**PSE&G** Public Service  
Electric and Gas  
Company

August 20, 1984

HOPE CREEK GENERATING STATION  
DOCKET NO. 50-354  
DRAFT SAFETY EVALUATION REPORT  
OPEN ITEM STATUS

Attachment 1 is a current list which provides a status of the open items identified in Section 1.7 of the Draft Safety Evaluation Report (SER). Items identified as "complete" are those for which PSE&G has provided responses and no confirmation of status has been received from the staff. We will consider these items closed unless notified otherwise. In order to permit timely resolution of items identified as "complete" which may not be resolved to the staff's satisfaction, please provide a specific description of the issue which remains to be resolved.

220.21-37  
 FIGURE ~~101~~

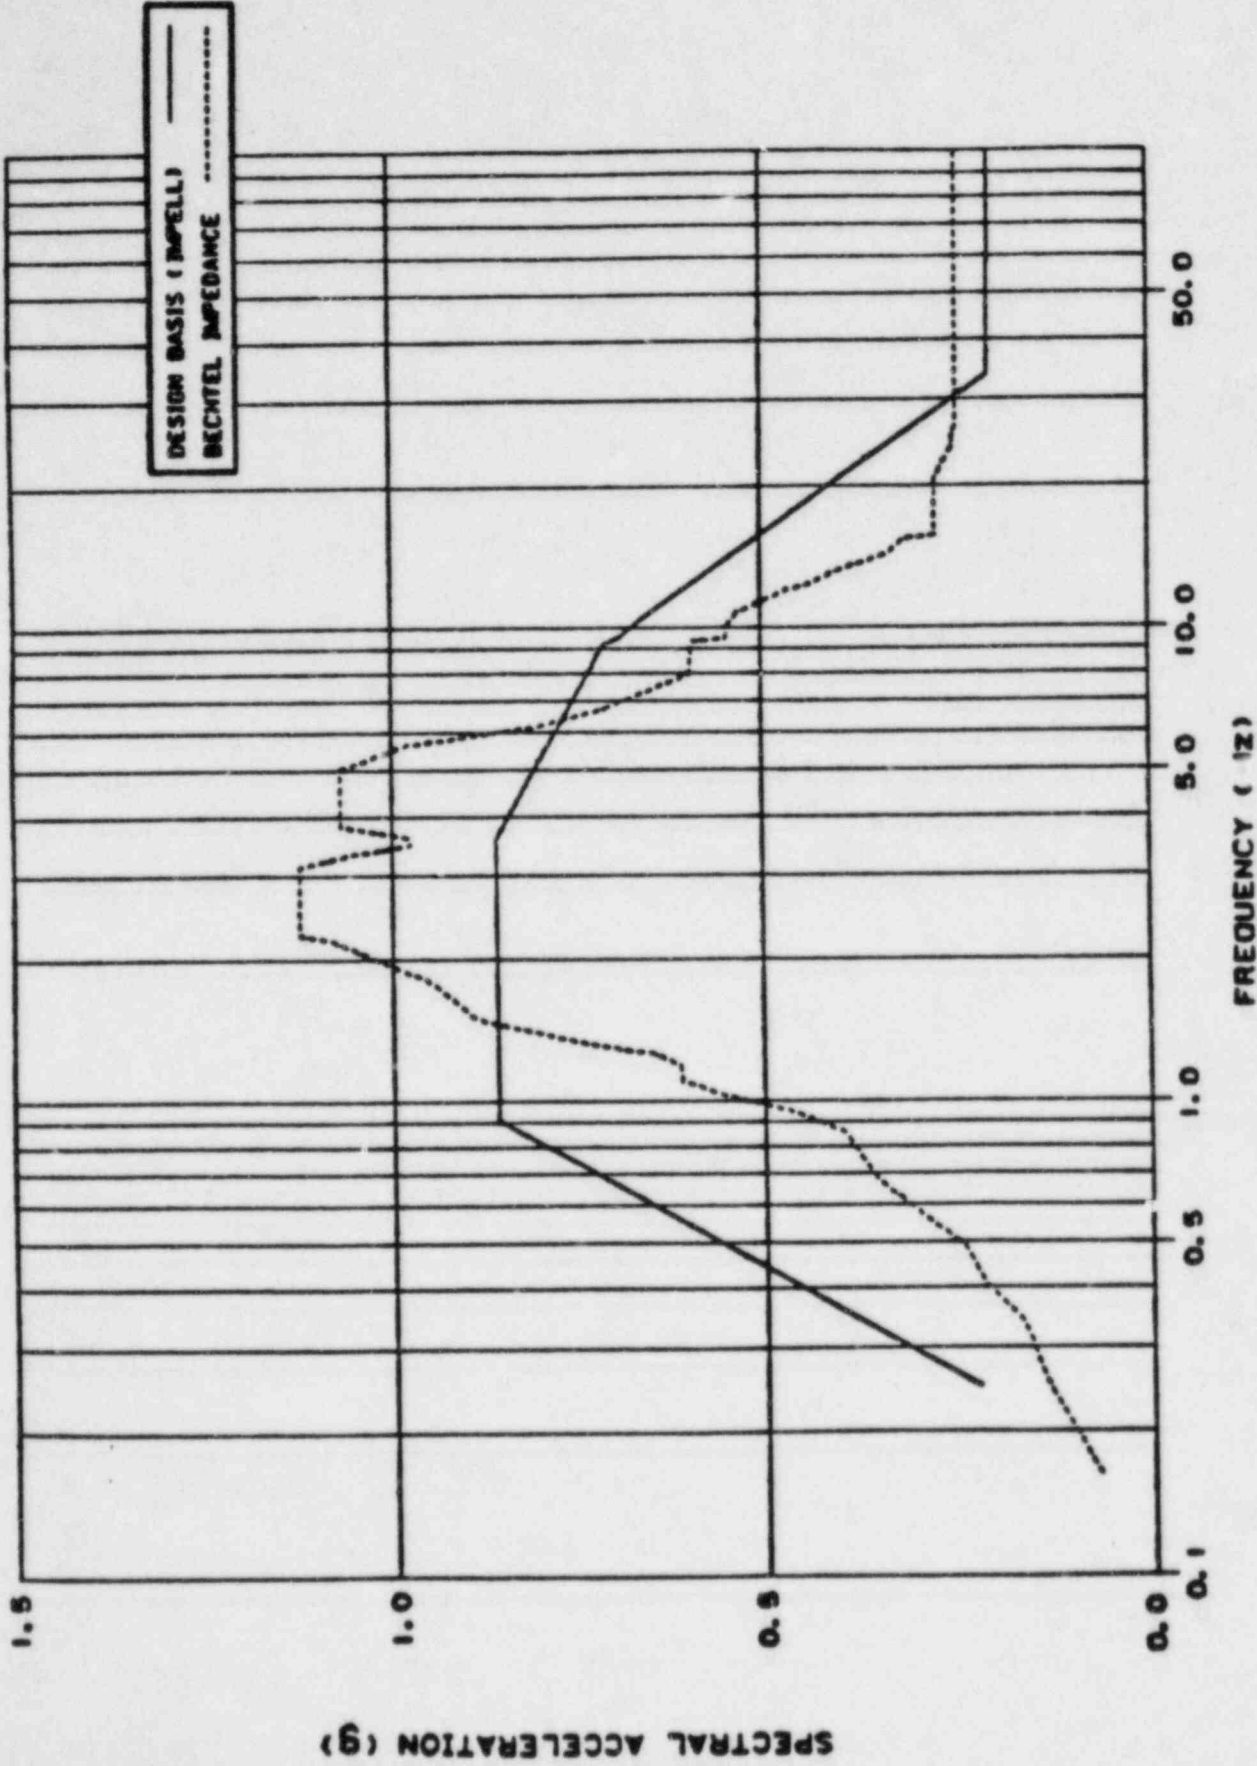
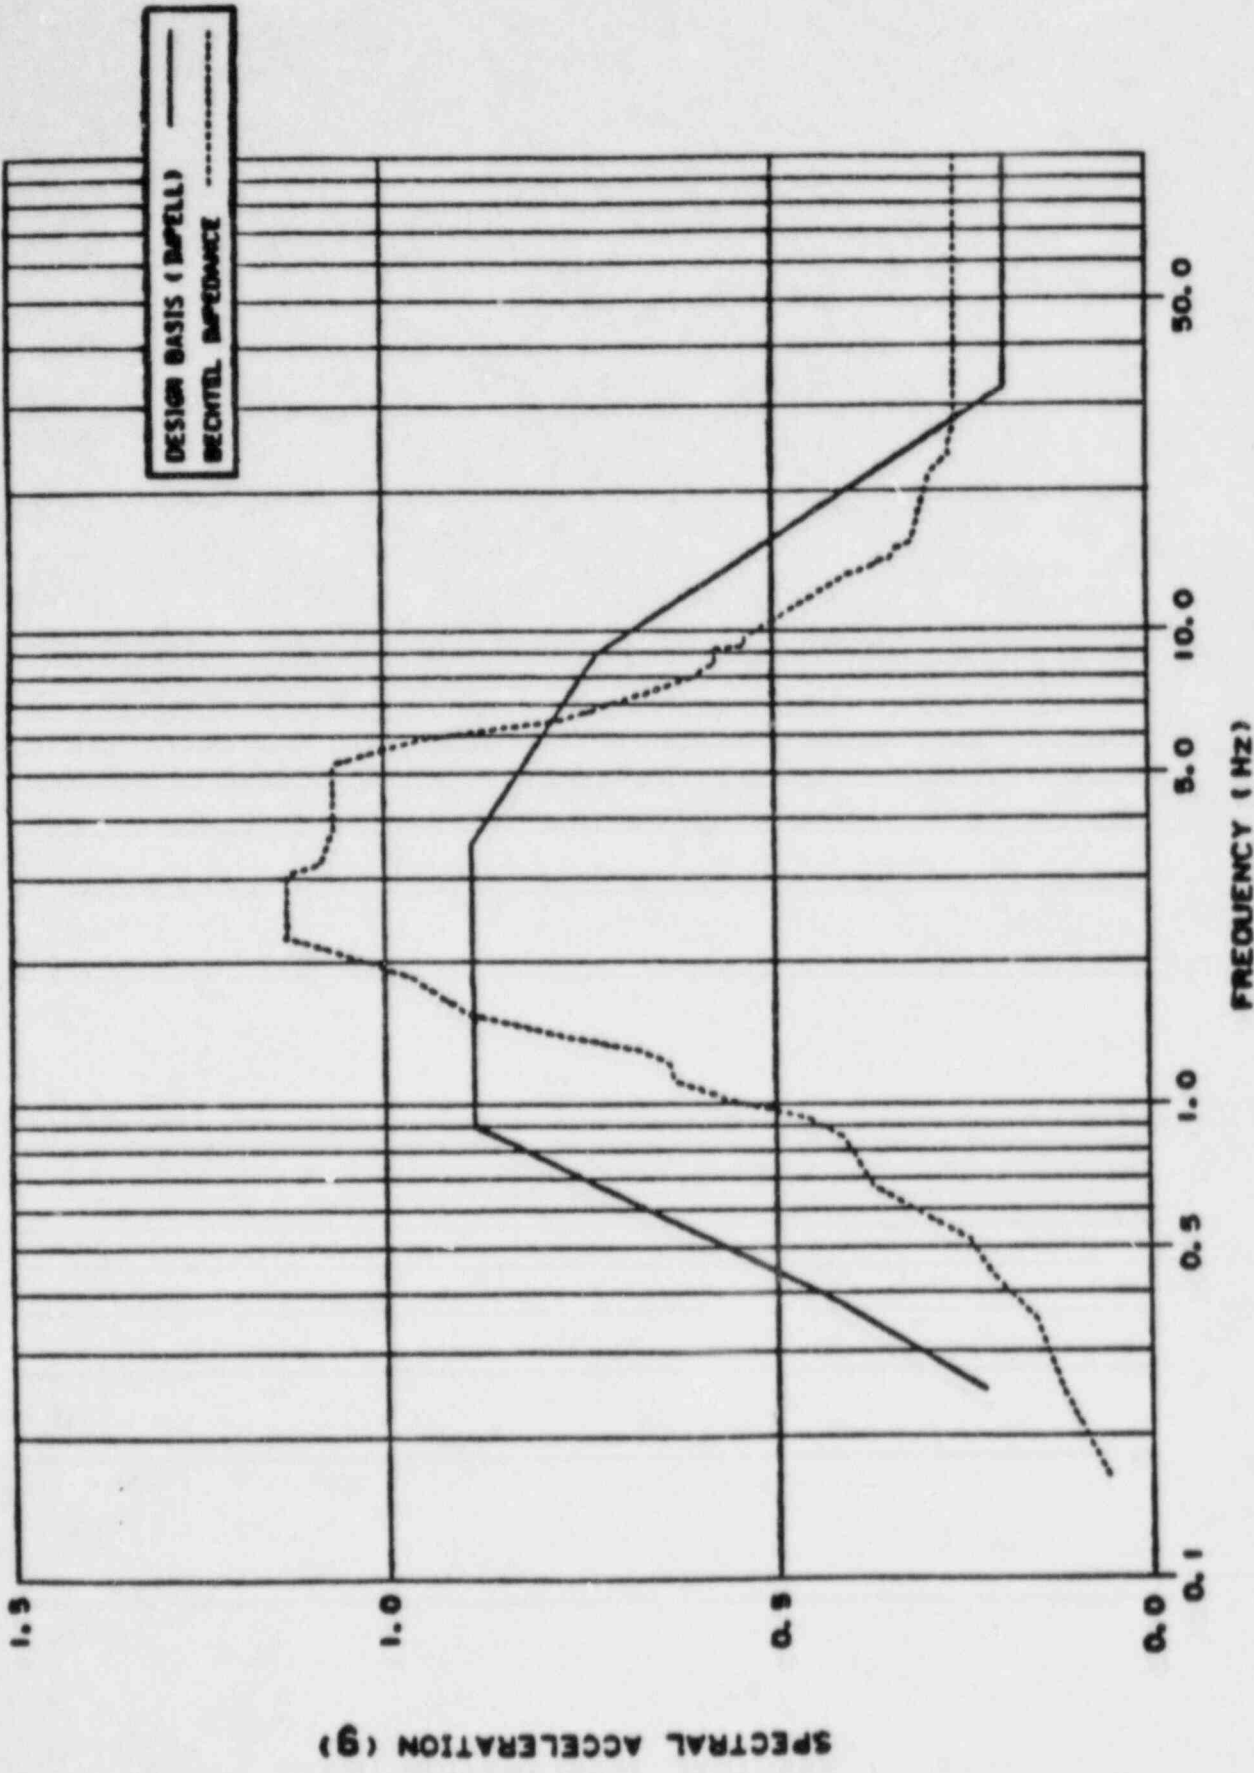
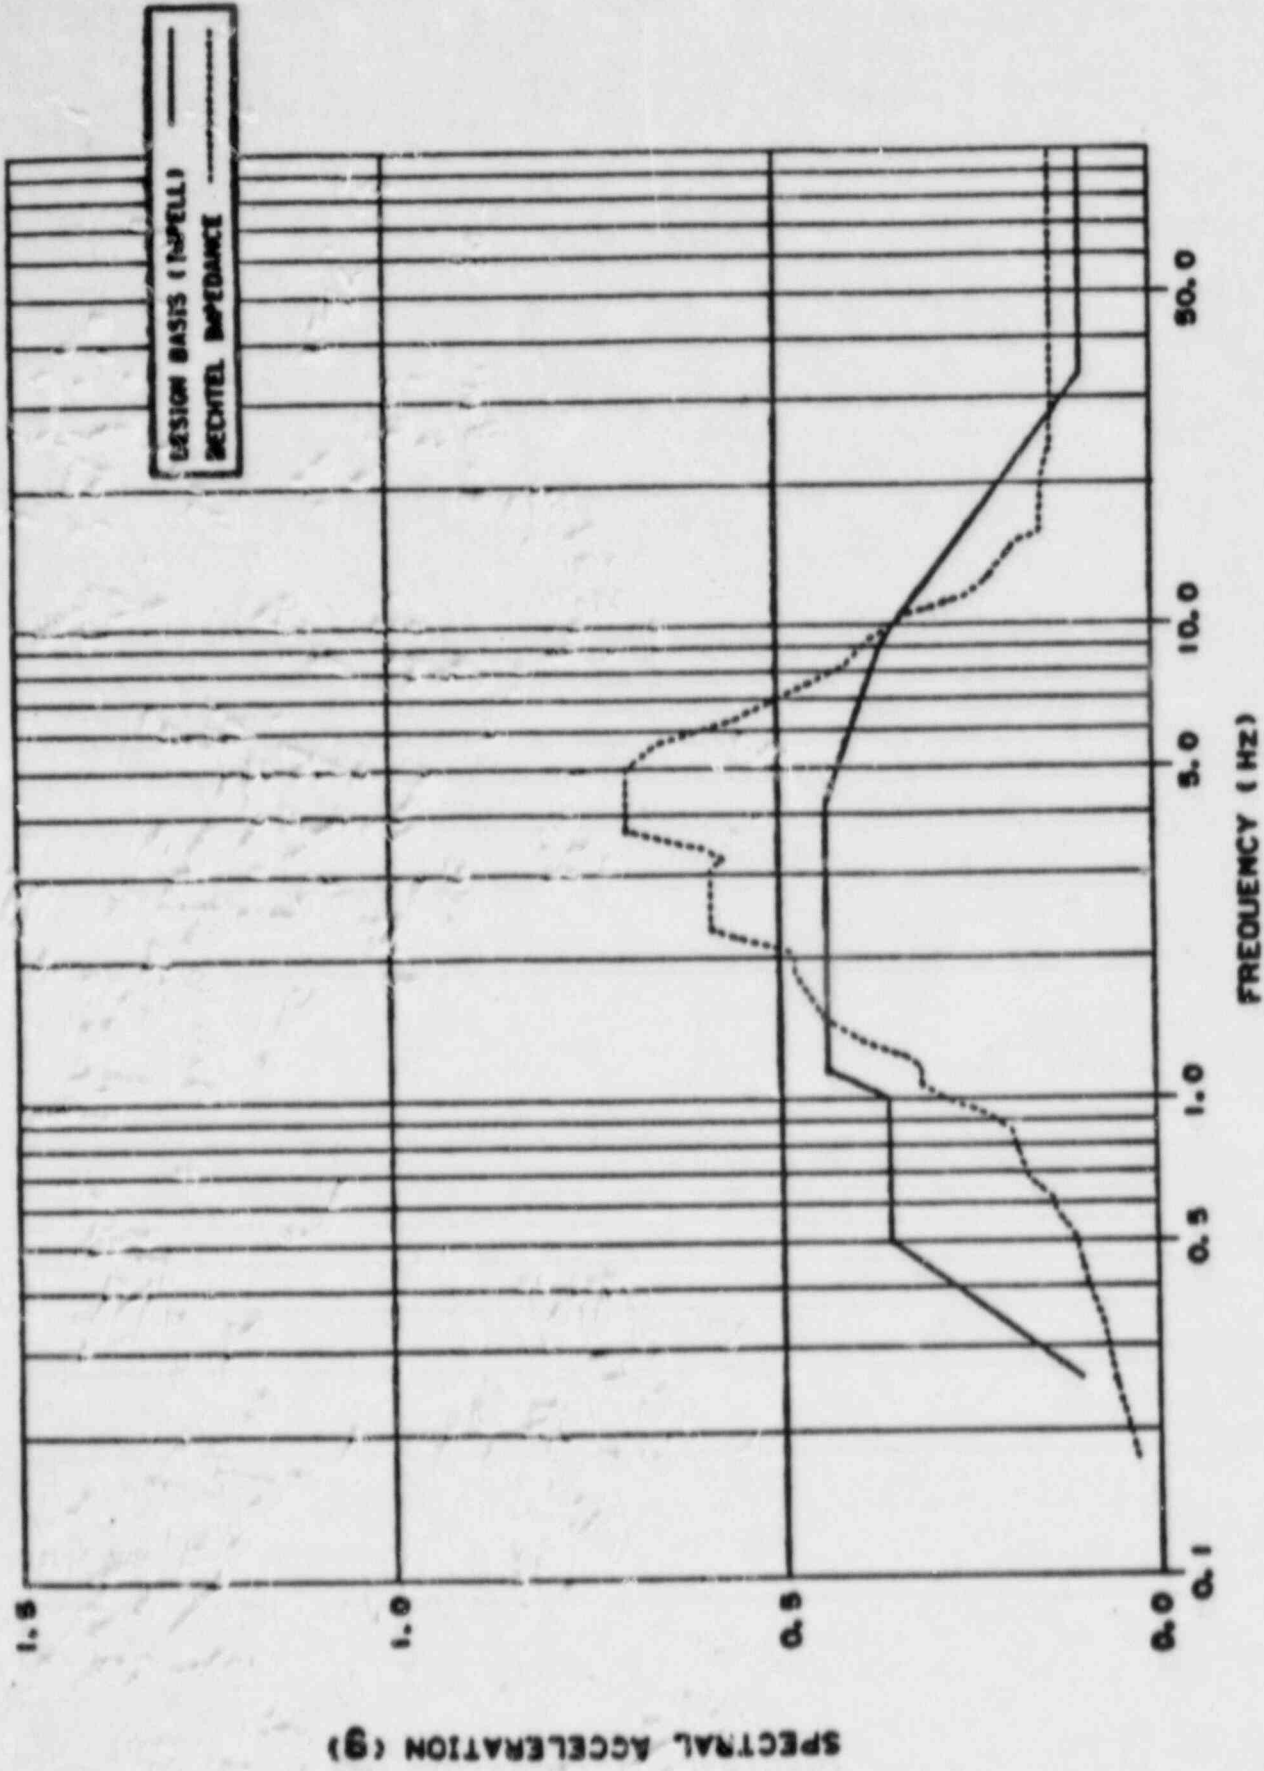
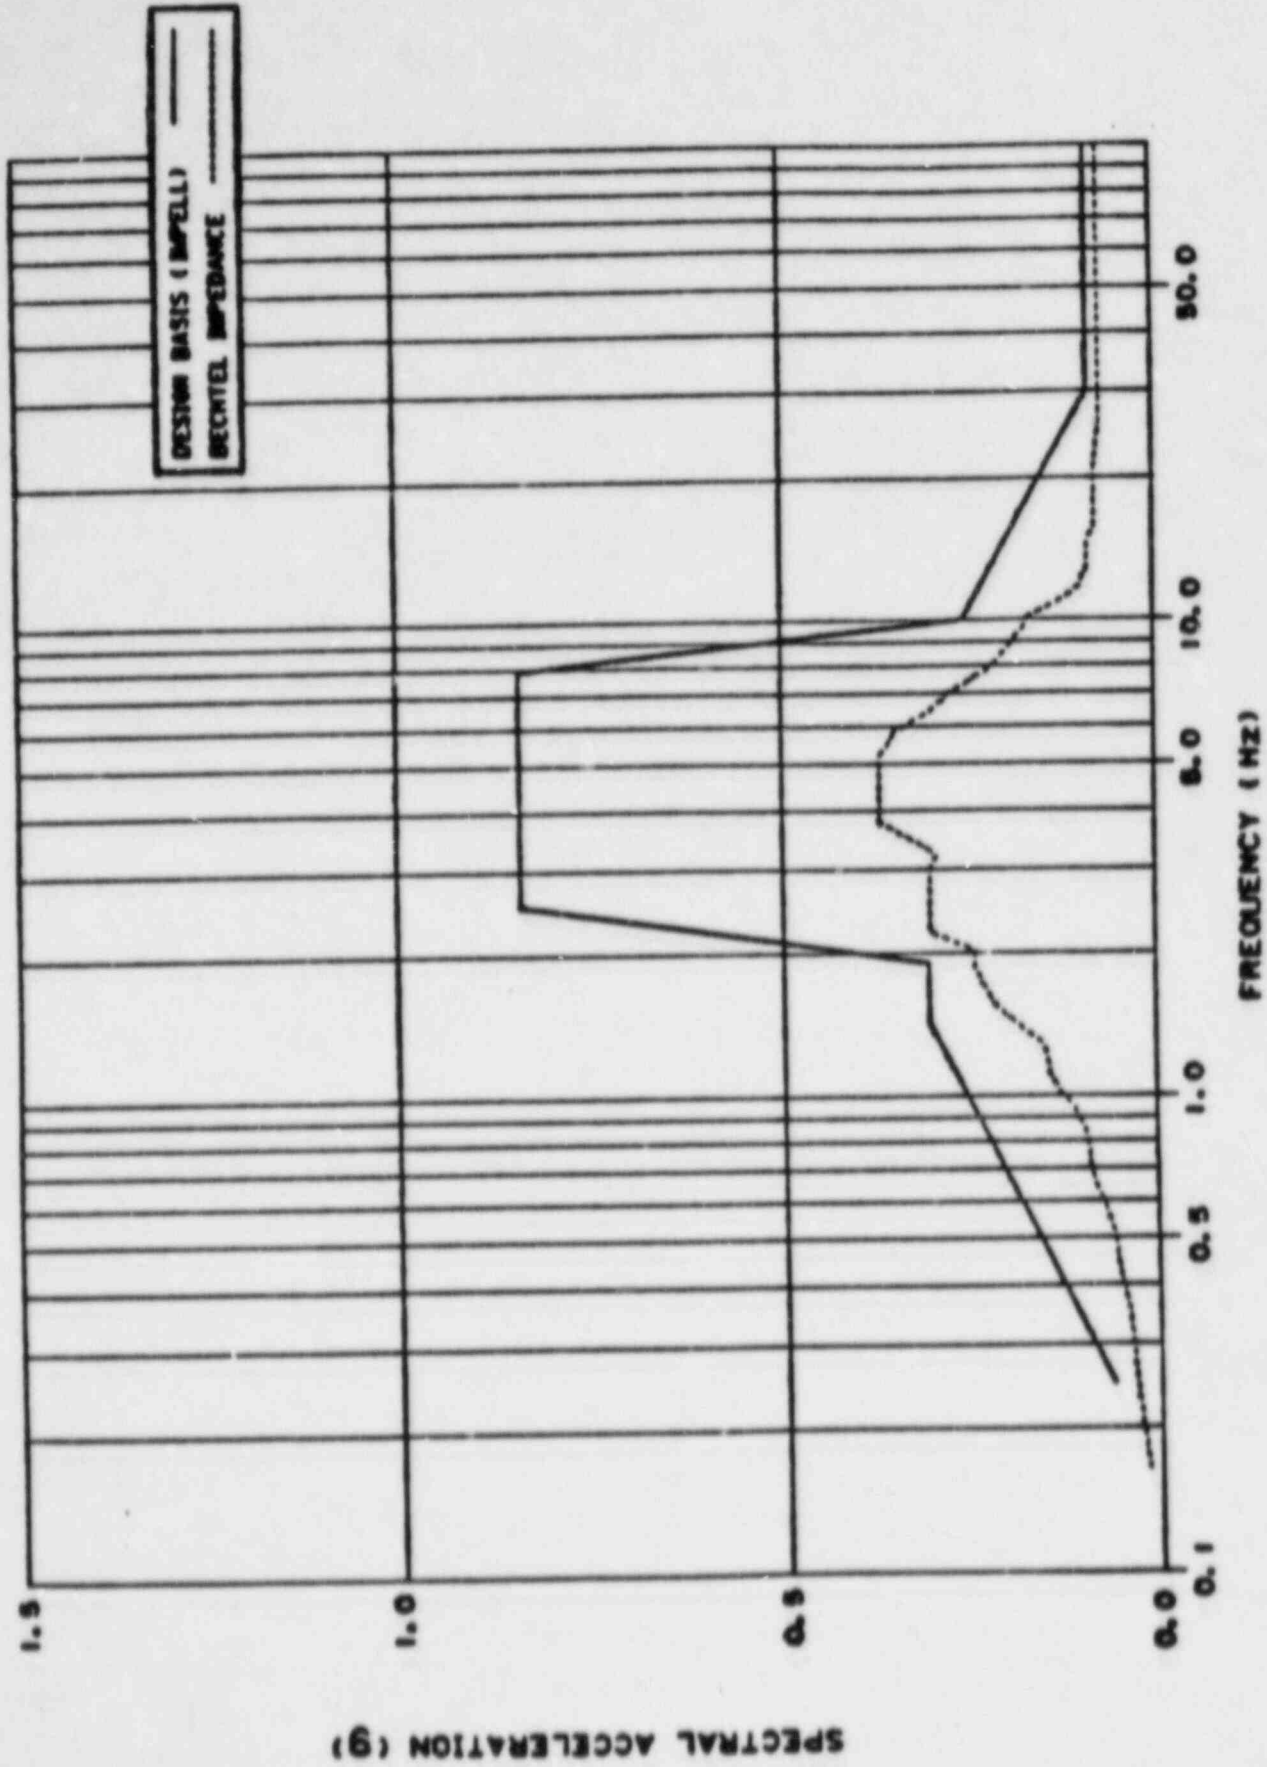
Figures 220.21-1 through 220.21-54 show a comparison of the 2 percent damping response spectra obtained from the design basis finite element and the impedance analyses for the reactor building, auxiliary building and the service water intake structure (SWIS).

¶ For the reactor and auxiliary buildings, the peak spectral accelerations obtained from the impedance analysis are generally lower than those obtained from the design basis analysis. However, the impedance analysis response spectra are not completely enveloped by those obtained from the design basis analysis, especially in the frequency range from 1.0 to 3.5 Hz. Also, there are some local exceedances in the higher frequency range, as shown in Figures 220.21-1 through 220.21-36. ¶ For the SWIS (Figures 220.21-37 through 220.21-54), the impedance analysis response spectra are generally enveloped by those obtained from the design basis analysis at elevation 114.0 feet. For other elevations, the impedance analysis spectral accelerations exceed the design basis spectral accelerations in some frequency ranges. These ranges vary approximately between 1.5 and 10.0 Hz.

In all cases, the items reviewed during these sampling studies can accommodate the loads resulting from the impedance analysis. Therefore, the impedance analysis results have no impact on the plant design.
